Riverside County Transportation Department
Summary of Bids
Advertised: June 2, 2015 (Agenda Item: 3-28)
Addenda: 1 (6/25/2015), 2 (7/09/2015), 3 (7/16/2015), 4 (7/24/2015), 5 (7/29/15), 6 (8/6/2015)
Bids Open: 2 pm Date: Wednesday, August 12, 2015

PROJECT: Clinton Keith Road Construction Project - Phase 2
From Whitewood Road to Leon Road
In the City of Murrieta and French Valley Area
Project No. B2-04722

MODIFICATIONS / CLARIFICATIONS TO SPECIAL PROVISIONS:

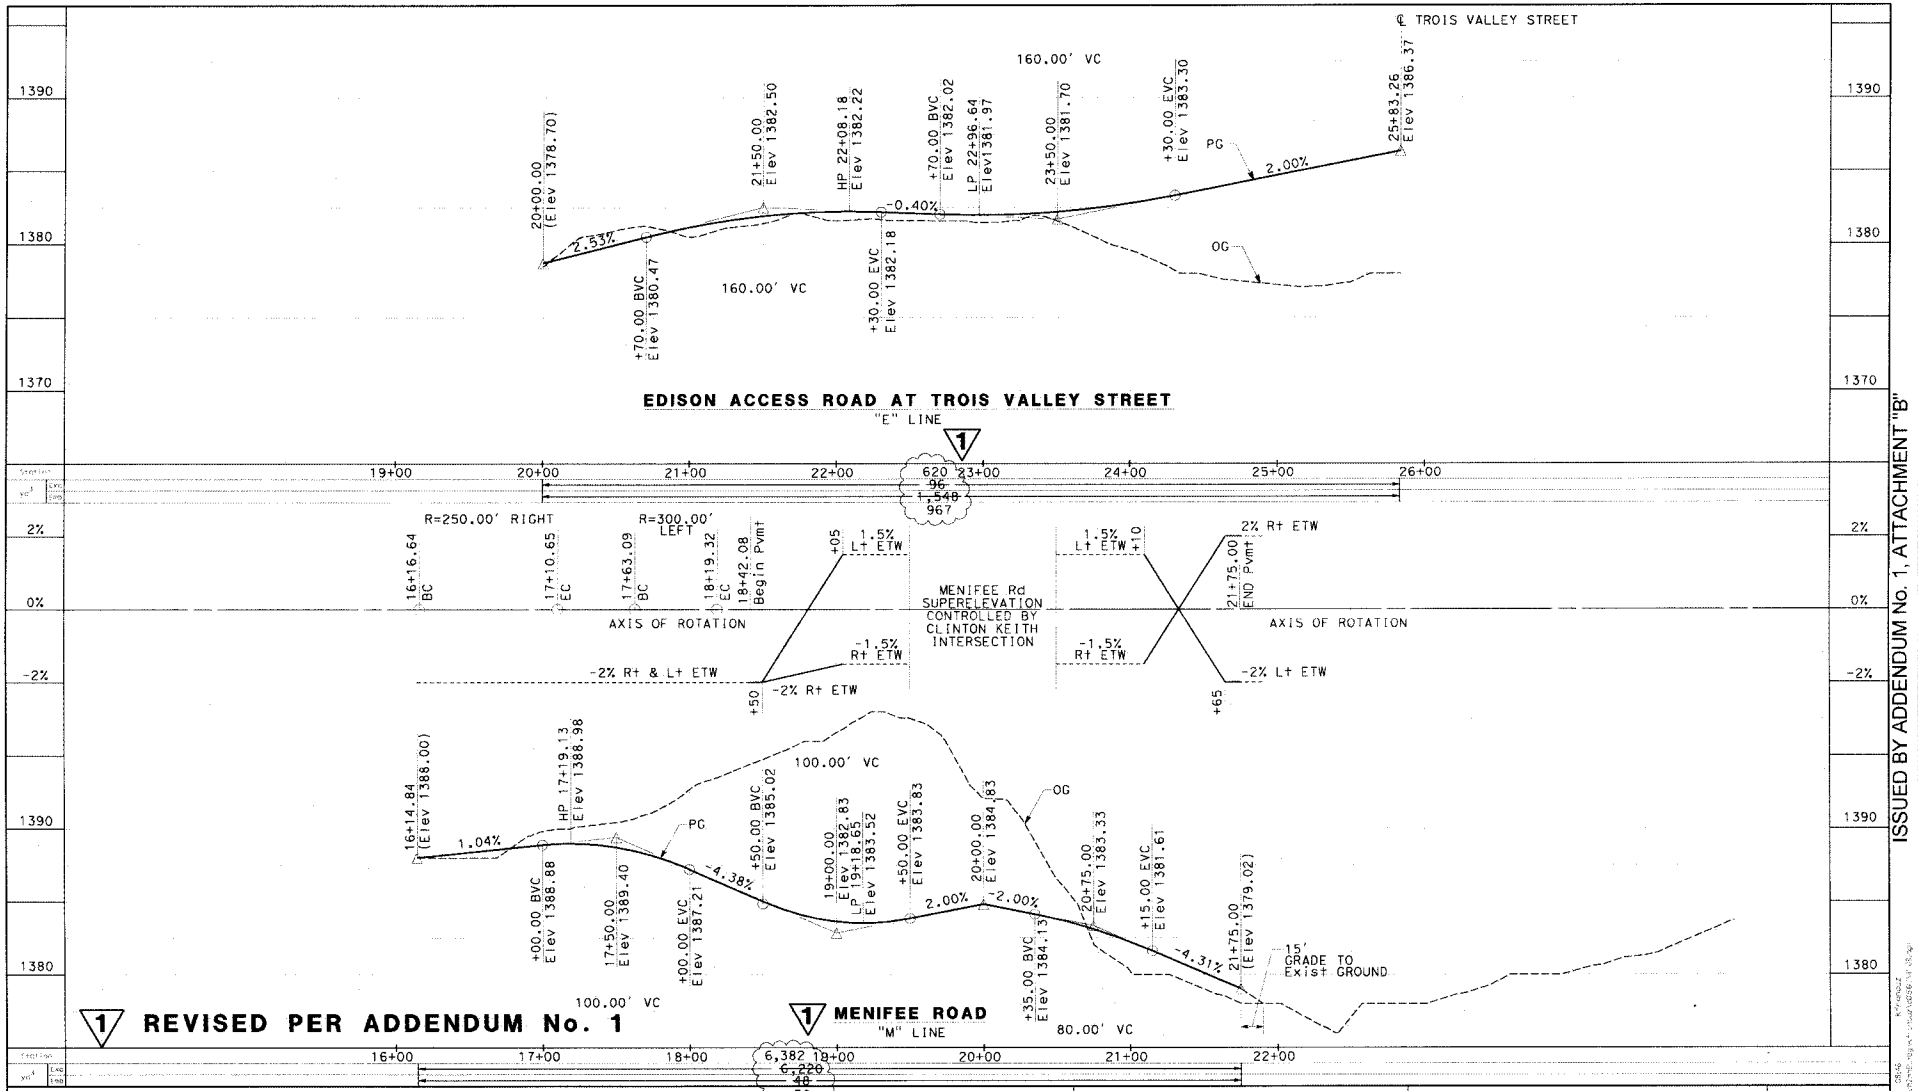
REVISED PER ADDENDUM No. 1

SHEET
28 of 191
PROJECT No. B2-0472
ARCHIVE No. 962-W
ISSUED BY ADDENDUM No. 1, ATTACHMENT "B"

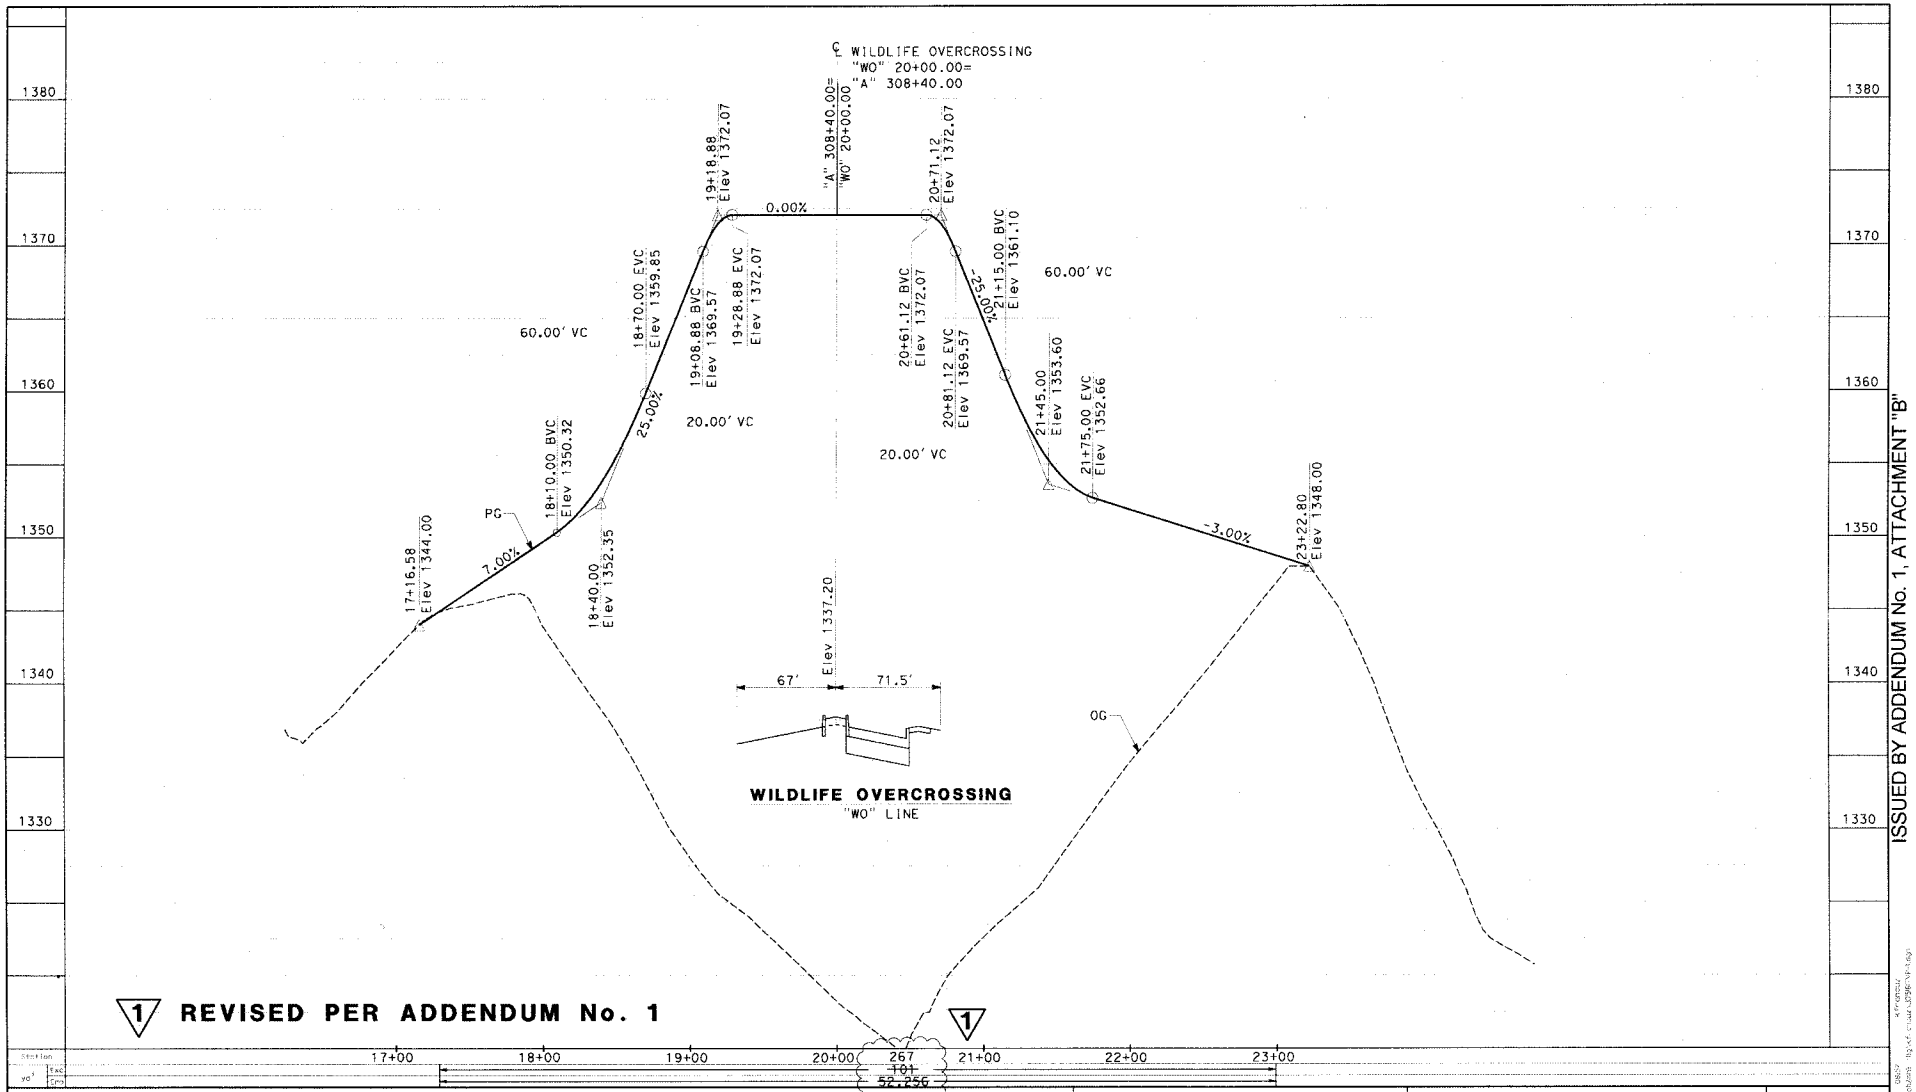
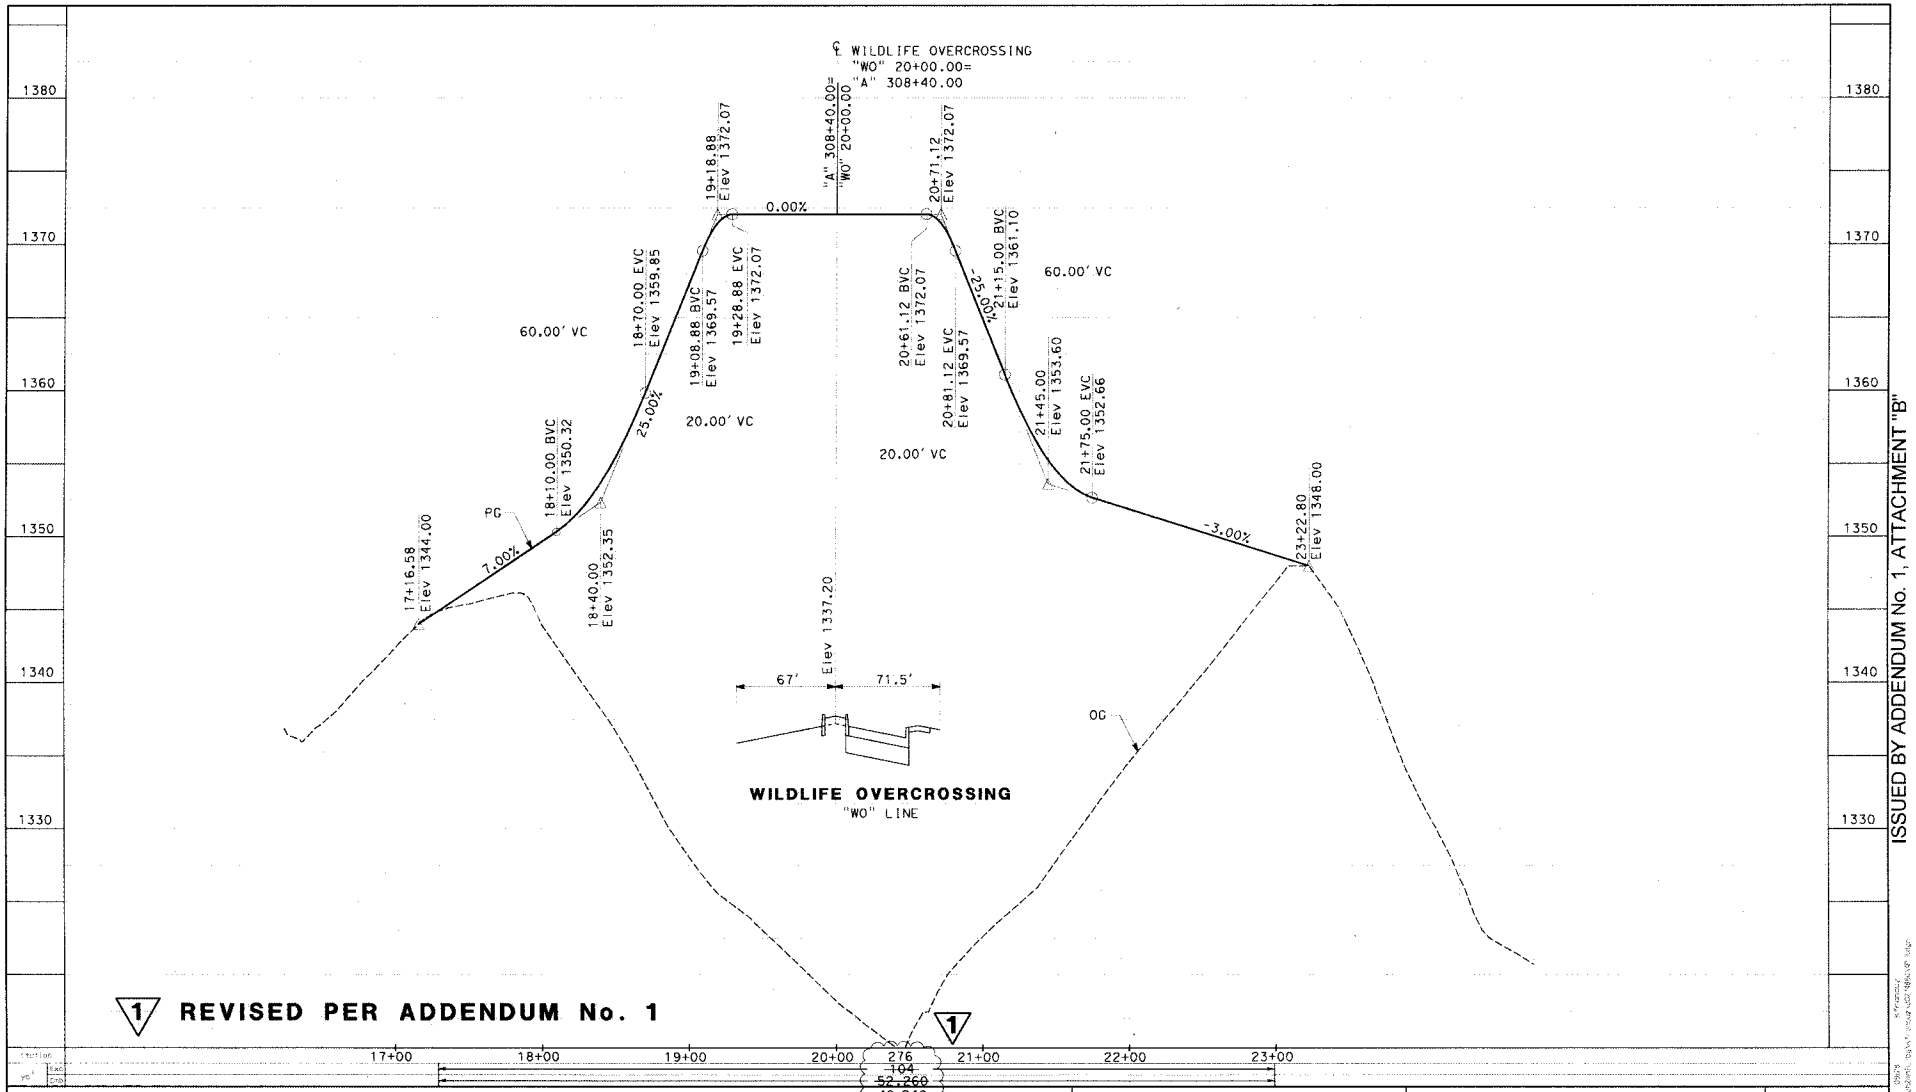
71.5'
OG
WILDLIFE OVERCROSSING
"WO" LINE
1380
1370
1360
1350
1340
1330
REVISED PER ADDENDUM No. 1
17+00
18+00
19+00
20+00
21+00
22+00
23+00
267
101
52,256
49,244
Don't Dig... Until You Call U.S.A. Toll Free
800-227-2600
for the location of buried utility lines.
Don't disrupt vital services.
TWO WORKING DAYS BEFORE YOU DIG
SCALES: 1" = 40' HOR
1" = 4' VER
CH2MHILL ENGINEERING COMPANY
APPROVED BY:
ALICIA L CANNON
PROJECT MANAGER
APRIL 14, 2015
DATE
DESIGNED BY CO
DRAWN BY KF
CHECKED BY AC
PROFILE
CLINTON KEITH ROAD
FROM
WHITEWOOD ROAD TO LEON ROAD

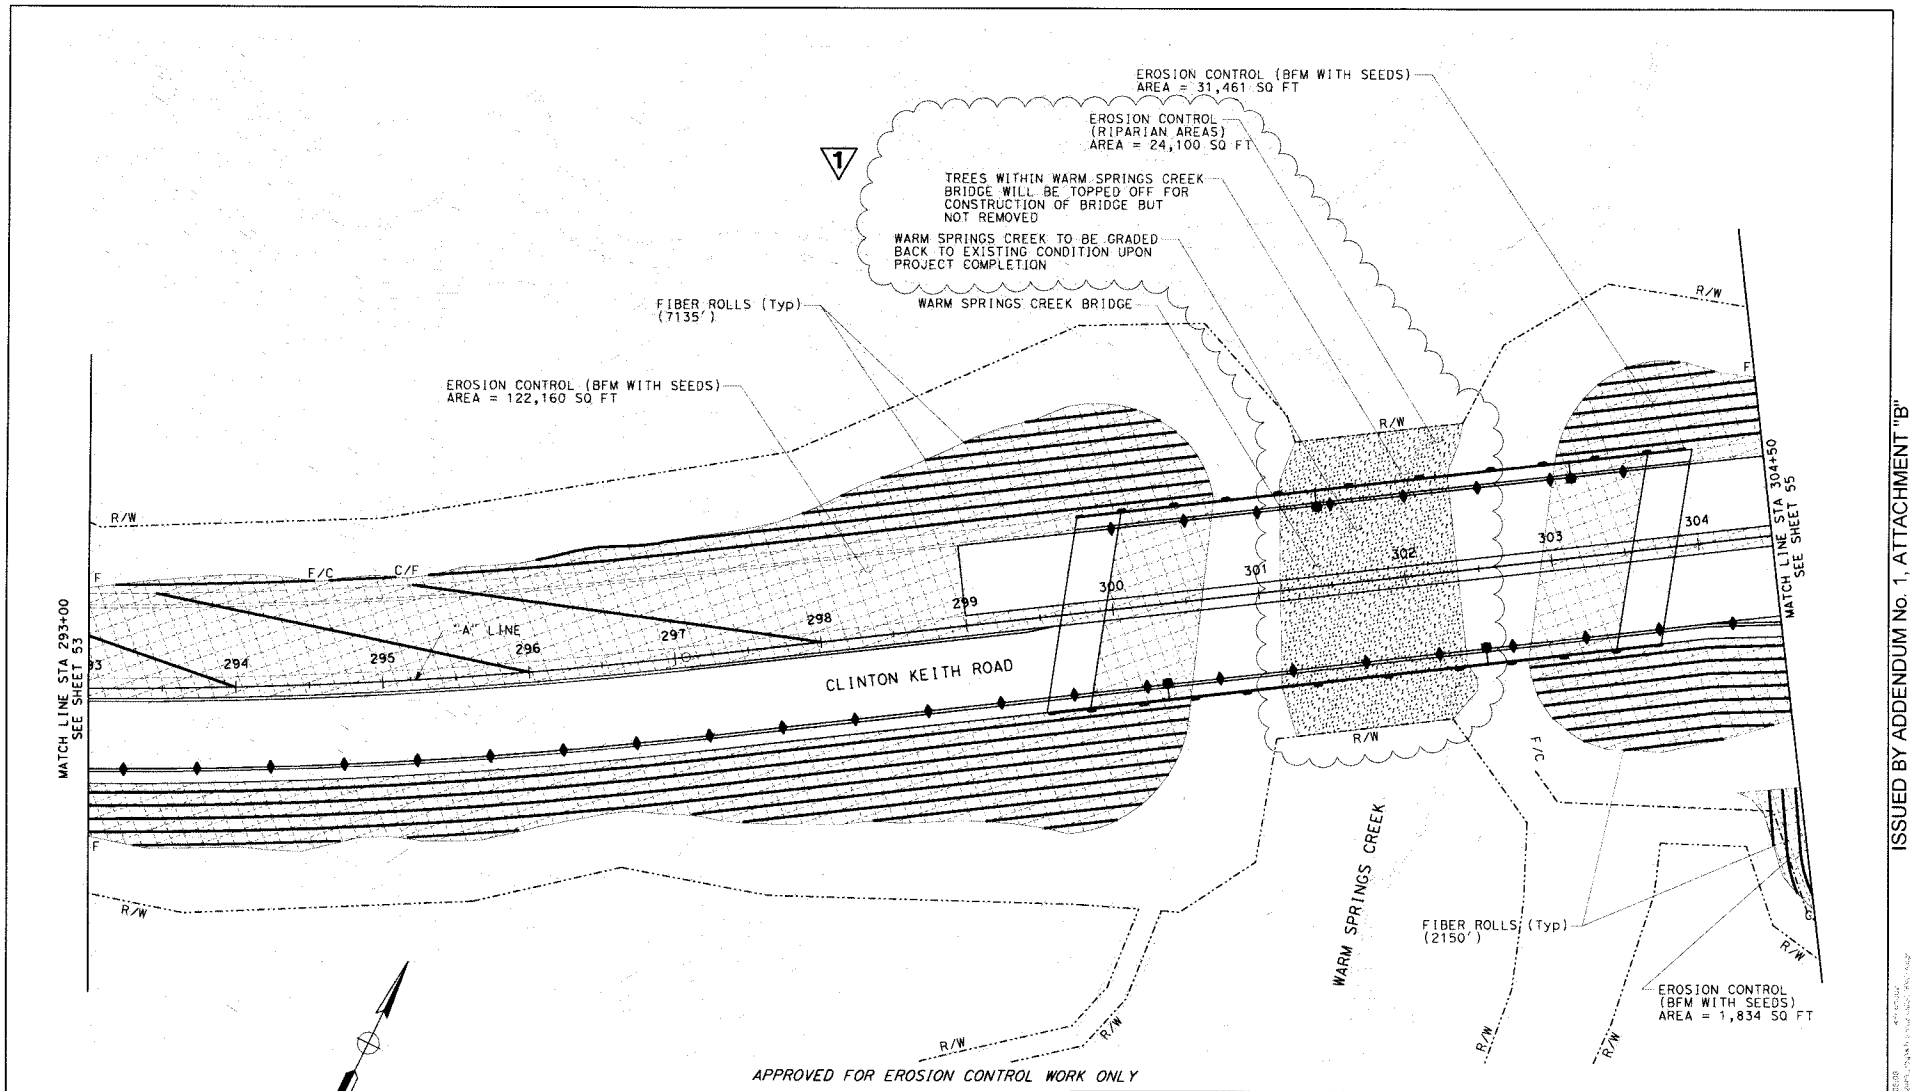
1 REVISED PER ADDENDUM No. 1

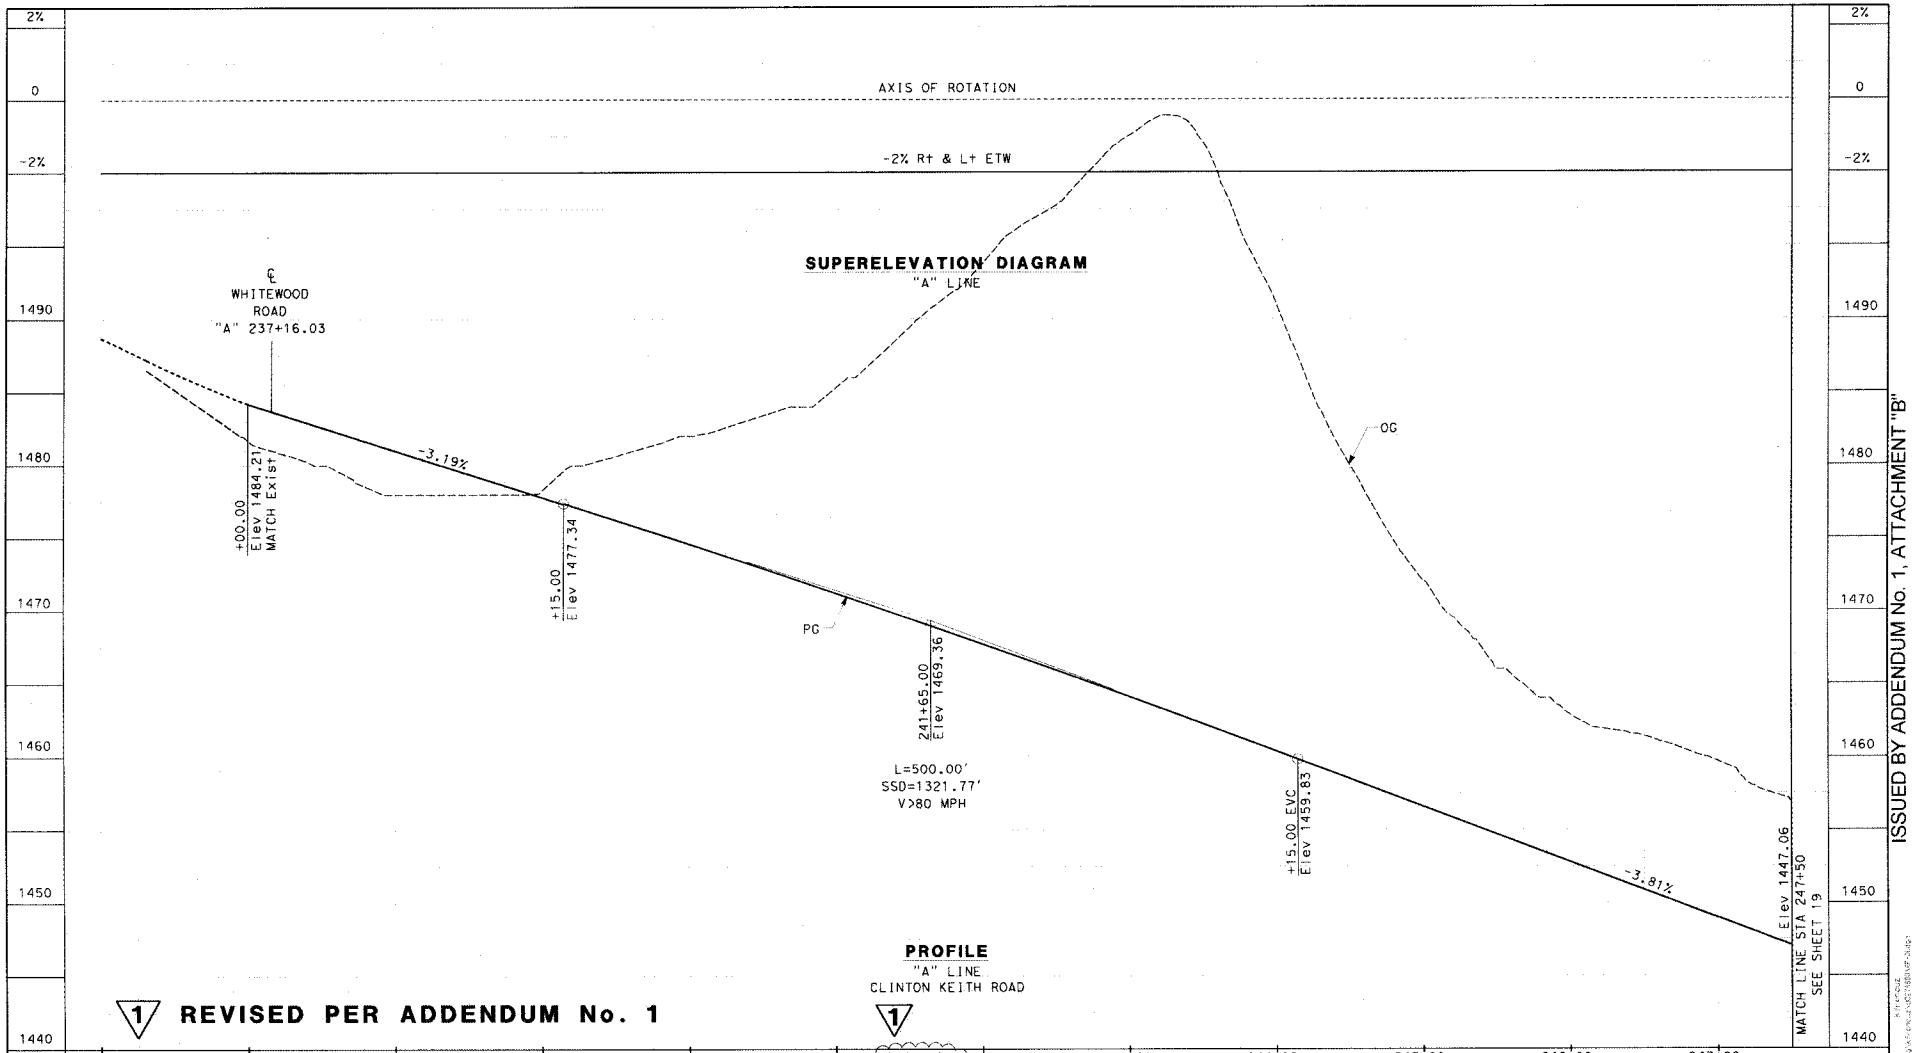
1 REVISED PER ADDENDUM No. 1
